SR-001 Wall-column concrete ownership and force-transfer review

SIMULATED COORDINATION REVIEW CASE STUDY | NOT FOR CONSTRUCTION | 2026-09-13

SR-002 Beam-wall section, diagnostic results and remaining design gates

B2 PLAN / 1:10 / analytical slice z = +2.00 m

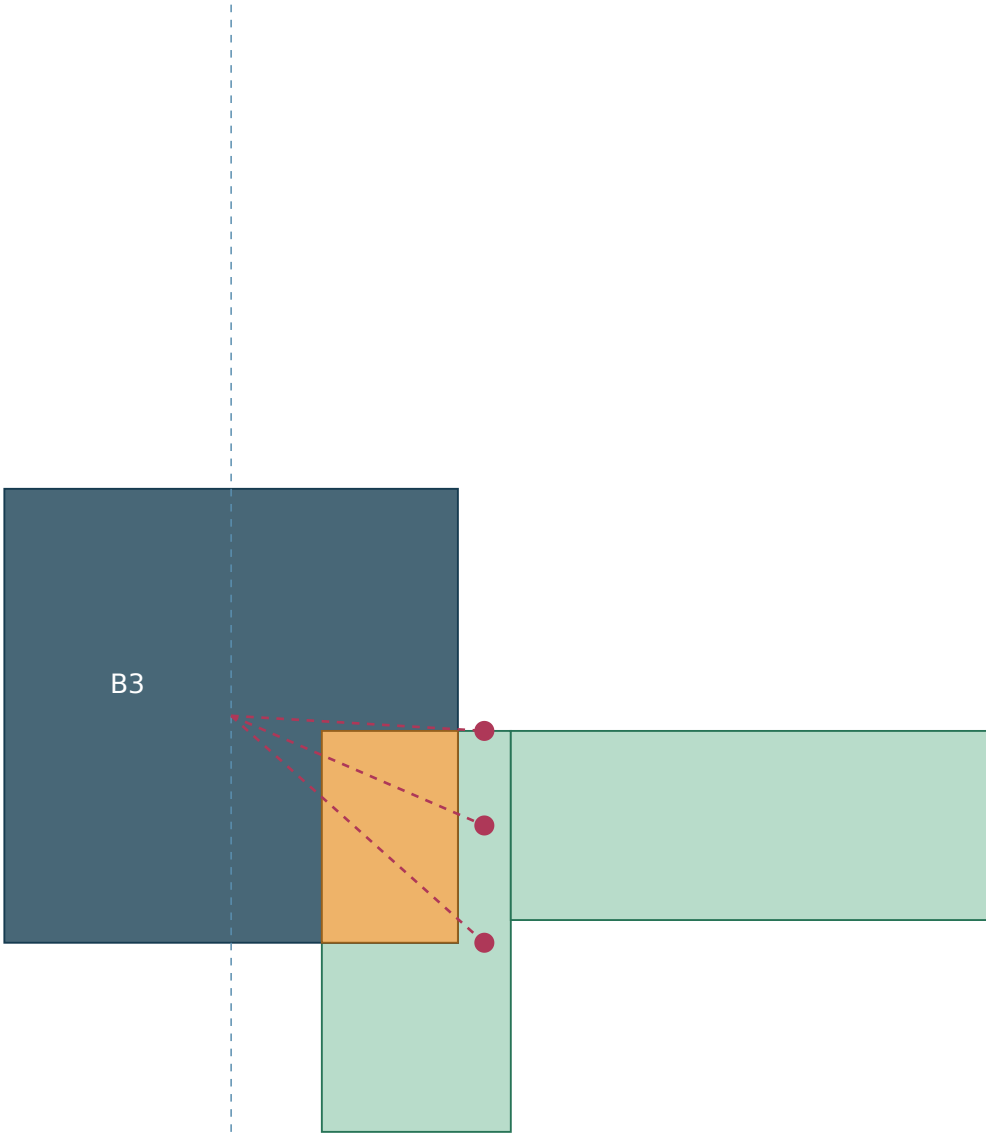
Same physical frame and core. Coloured partitions identify concrete ownership; they do not change member outlines.

Wall x = 6.12..6.37; remaining strip x = 6.30..6.37 m.

Column axis x = 6.00; remaining wall midplane x = 6.335 m.

The 70 mm strip belongs to one monolithic wall-column section; it is not a separate proposed thin wall.

B2 north face y = 4.50; portal starts y = 4.60. Finished portal width remains 1.28 m.

Elastic contact forces are available in case_joint_actions.csv. Bond slip, joint shear flexibility and RC reinforcement remain open.

B-Y-B-23-2F / transverse section / 1:9.52

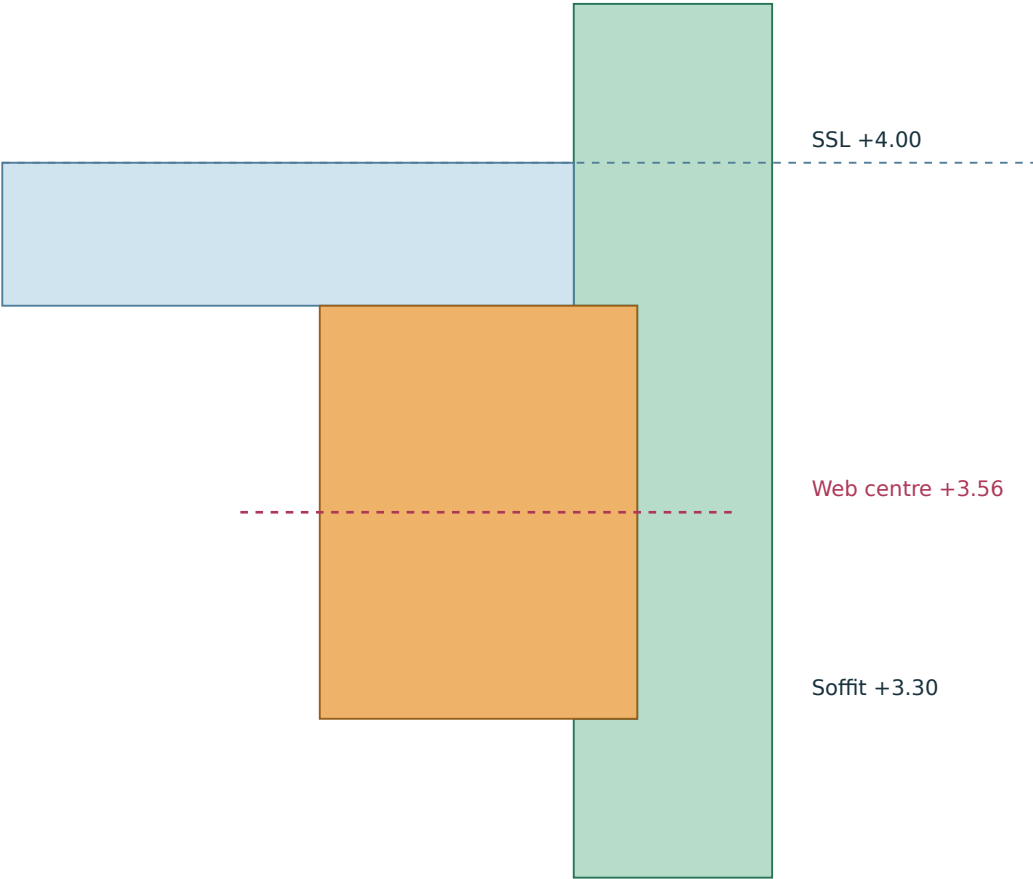
Section through the B-line rear-bay beam at 2F. Concrete outlines are unchanged; the analytical web centroid is corrected.

Web: 0.40 x 0.52 m; centroid 0.44 m below SSL.

Slab flange: 0.18 m; no second full-depth beam section.

Beam-owned overlap leaves 0.17 m wall at this section.

Remaining wall midplane x = 6.285 m; corner/contact offsets are explicit.
